**SITE PLAN REVIEW COMMITTEE  
MEETING AGENDA & STAFF REPORT**

**DATE:** Thursday, May 26, 2016  
**TIME:** 7:00 – 10:00 p.m.  
**PLACE:** 2100 Clarendon Boulevard  
Courthouse Plaza  
Room 109/110 (Cherry & Dogwood)  
Arlington, VA 22201

**ITEM 1**  
SP #413 Founders Square  
4040 Wilson Boulevard (RPC# 14-060-079)

## **ITEM 2**

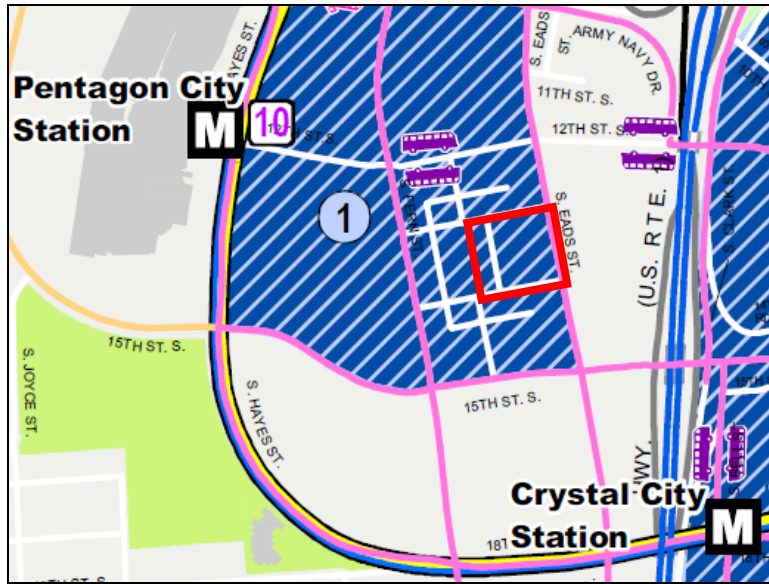
The proposal is largely successful in meeting these building design goals. The Design Guidelines do not specify a specific building taper by floor, and the design includes step-down heights at corners fronting Eads Street and the central park, with the building crown on the penthouse level set back from 14th Street. Building height is generally consistent with the Guidelines, which do not specify where the tallest point of the building other than suggesting a step back along 14th Street where the proposed tower is located. Staff acknowledges that this massing strategy is a response to that approved in Phase 4/5, and since future phases will similarly have to reflect this massing the proposal does not represent a departure from the Design Guidelines. The building incorporates a greater use of windows within the façade, but masonry is the primary building material, being used to frame windows in two-floor increments and as asymmetrical treatment within that frame. One element staff acknowledges as a departure is

clear establishment of the building base, as there is no cornice line, minor façade setback, or significant contrast in building color or material.
